UNITED STATES PATENT AND TRADEMARK OFFICE

10/575,860

Office Action Summary	Application No. 10/575,860	Applicant(s) KIM, KYU YOUNG	
	Examiner Philip H. Leung	Art Unit 3742

DETAILED ACTION

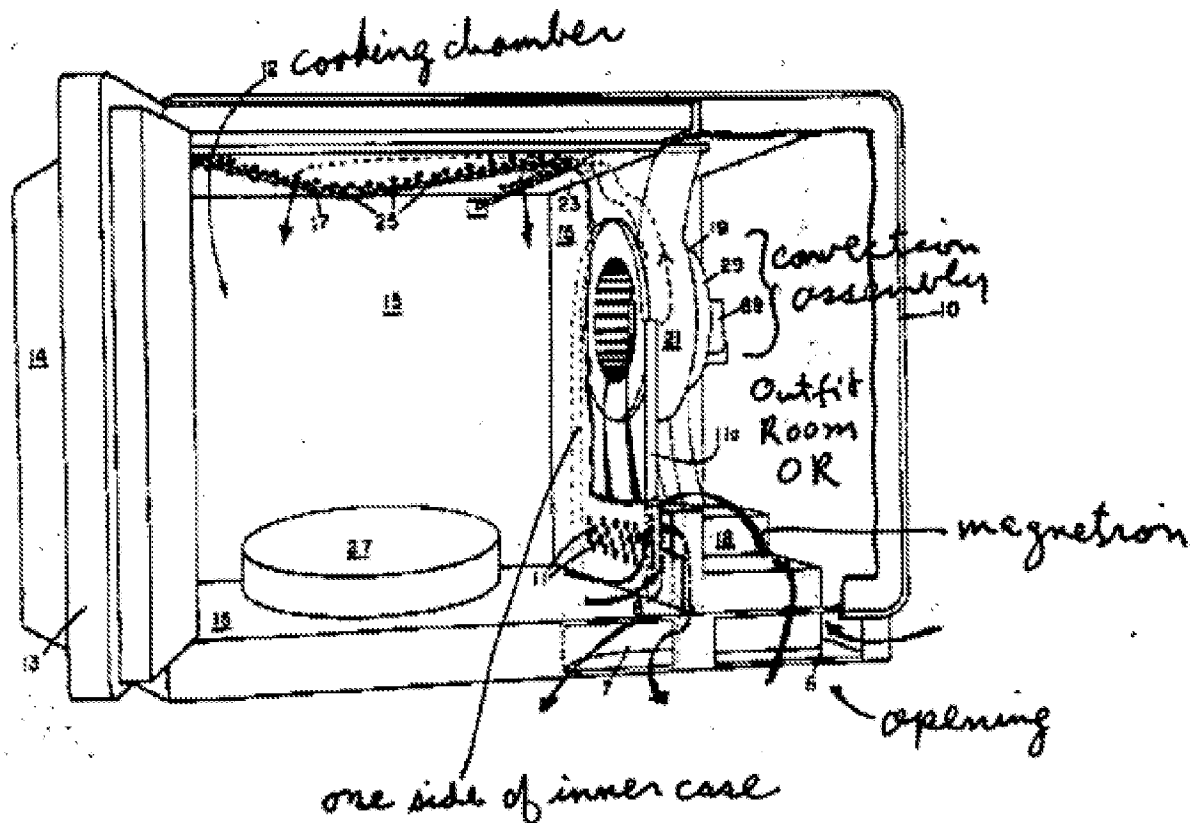
Klapper shows a microwave oven 2, comprising a body forming an outer appearance; an inner case in the body having a cooking chamber 1 formed therein, the inner case having a pair of side walls 15, a rear wall, and top and bottom walls; an outfit room 19 provided at one of the pair of side walls of the inner case, the outfit room having a plurality of electric parts (such as fan 11, motor 14, heating element 12) mounted therein; and a convection assembly mounted at one of the pair of side walls 15 of the inner cases that transmits heat to the cooking chamber 1, wherein the convection assembly comprises: a convection heater 12 configured to generate heat for convection heating; and a convection fan 11 configured to transmit the heat generated by the heater to the cooking chamber, and wherein the convection heater is positioned adjacent the convection fan (see Figures 1 and 2 and the English abstract). Therefore, Klapper shows every feature as claimed except for the location of the magnetron and the transformer being in the outfit room. Larsen shows a microwave oven comprising: a body 10 forming an outer appearance; an inner case 15 in the body having a cooking chamber 12 formed therein; an outfit room (marked as OR) at one side of the inner case, having various electric parts, (including a magnetron 18, a high voltage transformer 92), mounted therein; and a convection assembly (19, 21, 29) mounted at a side of the inner case, for transmitting heat to the cooking chamber and a convection heater 17 for generating heat for convection heating (see the marked-up copy of Figure 1 below).

It would have been obvious to an ordinary skill in the art at the time of invention to modify Klapper to locate the magnetron and transformer together with the convection assembly including the convection fan so that the oven enclosure can be more compact and the heat generating components, such as the magnetron and the transformer can be more effectively cooled, in view of the teaching of Larsen.
